Fixing the List Config/Cycle Timer state machine race conditions

Re: Q-rev/D1.0 SA ballot comment I-22, 802.1 maintenance item 0319. Following up Alon Regev's work.

Mick Seaman mickseaman@gmail.com

Net mgmt./List Config/Cycle Timer/List Execute configuration—current (1)

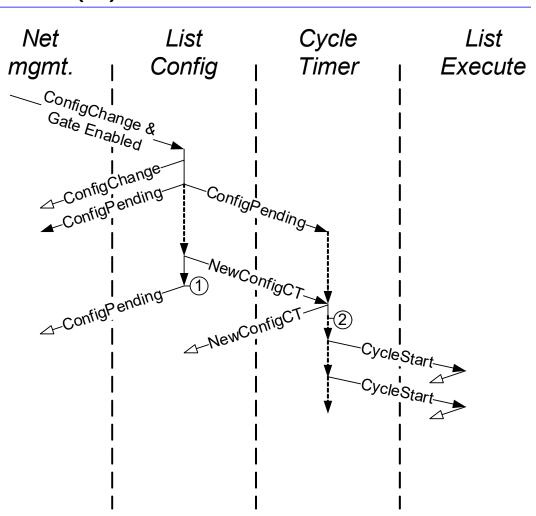
Configuration change race

State machines do not constrain the execution order of List Config:UPDATE_CONFIG and Cycle Timer:SET_CYCLE_START_TIME, (1) and (2) in the Figure.

(1) clears ConfigPending, which affects setCycleTimer() processing at (2).

SetCycleStartTime() can be executed by toggling GateEnabled, so a change to clearing ConfigPending in the Cycle Timer machine needs to be conditional. Maintenance item 0319 proposes an extra state to clear the varaiable, but also clears it on one condition in the procedure.

Net mgmt./List Config/Cycle Timer/List Execute configuration—current (2)

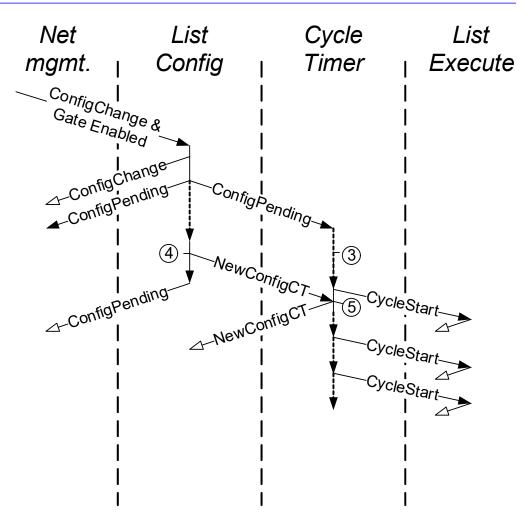
Another race?

In the Cycle Timer machine, if ConfigPending and ConfigChangeTime is no later than CurrentTime + OperCycleTime + OperCycleTimeExtension then SetCycleStartTime case (d) delays the next CycleStartTime to ConfigChangeTime.

State List Config:UPDATE.. is entered when ConfigChangeTime <= CurrentTime and Cycle Timer:START_CYCLE is entered when CycleStartTime <= CurrentTime, i.e. at the same time following case (d) above. Execution of the two states is mutually exclusive, but either can precede the other. List Execute:NEW_CYCLE can be entered as soon as START_CYCLE has executed, so can precede List Config:UPDATE..., and can take the first item from the old OperControlList before that list is updated.

A better Cycle Timer machine (1)

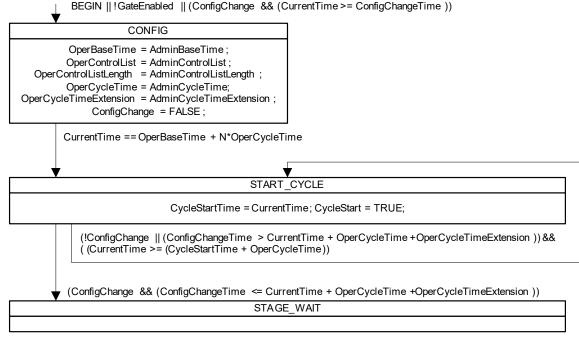
Don't use SetCycleStartTime() to test Config Pending and hide the significant state difference between:

- continuing an established set of cycles (with one set of Oper .. parameters)
- setting up a new, possibly delayed set of cycles with a new set of Oper.. parameters

Don't split the logic for a new set of cycles between machines. Add update functionality to the Cycle Timer, make the update conditions explicit [no need for SetCycleStartTime()]. All List Config (if kept) has to do is calculate Config Change Time. List Execute machine unchanged.

Current curiosities:

- 1. Oper.. variables only set when GateEnabled, race condition on start up [removed].
- 2.Cycle start skipped when one more cycle would fit before ConfigChangeTime.

A better Cycle Timer machine (2)

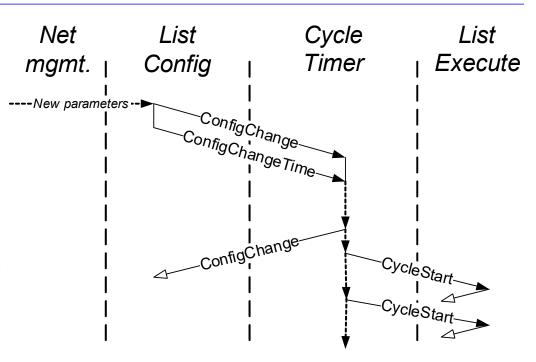
ConfigChange Time calculation, and ConfigChange set as a direct procedural result of a network management update of list parameters (no List Config machine required).

CycleTimer machine clears (resets) ConfigChange when the Oper.. variables have been updated with the new Admin variables [job done].

No need for ConfigPending or NewConfigCT.

But there are a lot of references to ConfigPending in Q-Rev/D1.0, including throughout the management clauses. Need to be sensitive to current implementations and users, sometimes fixing a mistake is a mistake.

Proposed Cycle Timer machine

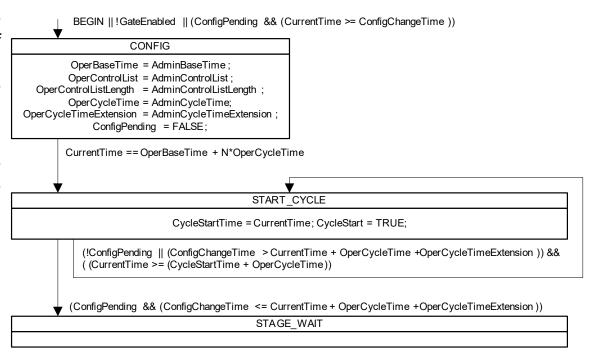
As on Slide 6, but substituting ConfigPending for ConfigChange. SetCycleStartTime() procedure (8.6.9.1.1) no longer used, move Notes to 8.6.9.1. Trivial changes to 8.6.9.4.8, 8.6.9.4.12, and 8.6.9.4.21—refer to the state machine, not the procedure. Trivial changes to PSFP MIB and ST MIB, remove references to 8.6.9.1.1, remaining references are sufficient.

Curiosity left unchanged:

1. Cycle start skipped when one more cycle would fit before ConfigChangeTime.

Net mgmt./List Config/Cycle Timer/List Execute configuration—proposed

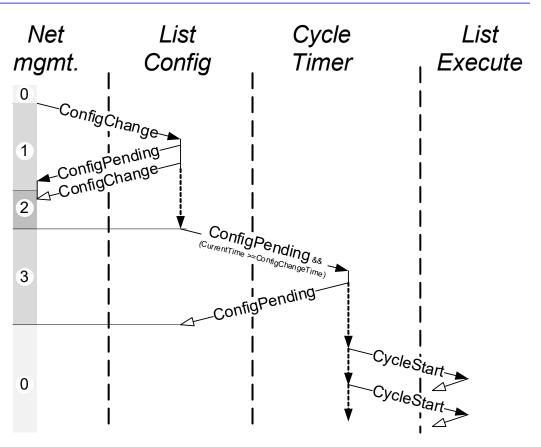
States/config progress:

0: !ConfigChange && !ConfigPending && (CurrentTime >= ConfigChangeTime)

List is executing, or will start executing at net possible Cycle Start time (or !GateEnabled)

1: ConfigChange && !ConfigPending

Probably not observable. List Config machine will set ConfigPending if !BEGIN,

2: <u>ConfigPending &&</u> (<u>CurrentTime < ConfigChangeTime</u>)

Update of Oper variables is pending.

3: <u>ConfigPending &&</u>
<u>(CurrentTime >= ConfigChangeTime) but</u>
<u>Oper.. variables not updated</u>

Probably not observable.

Proposed state machine overview (Figure 8-18)

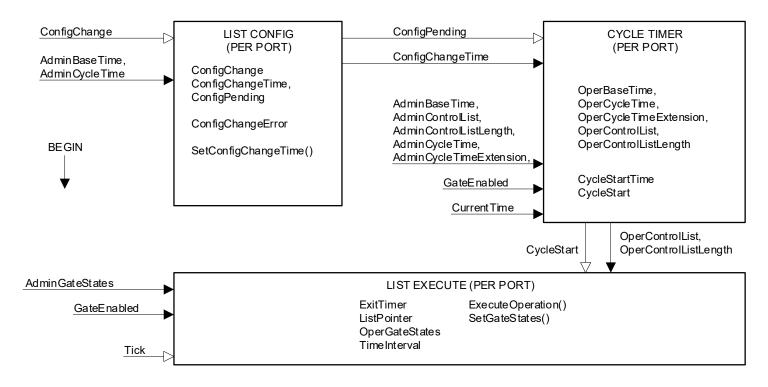
Remove NewConfigCT. Variables that are shown as communicating between machines are only shown inside their 'home' machine, i.e. the machine that is responsible for their initialisation on BEGIN.
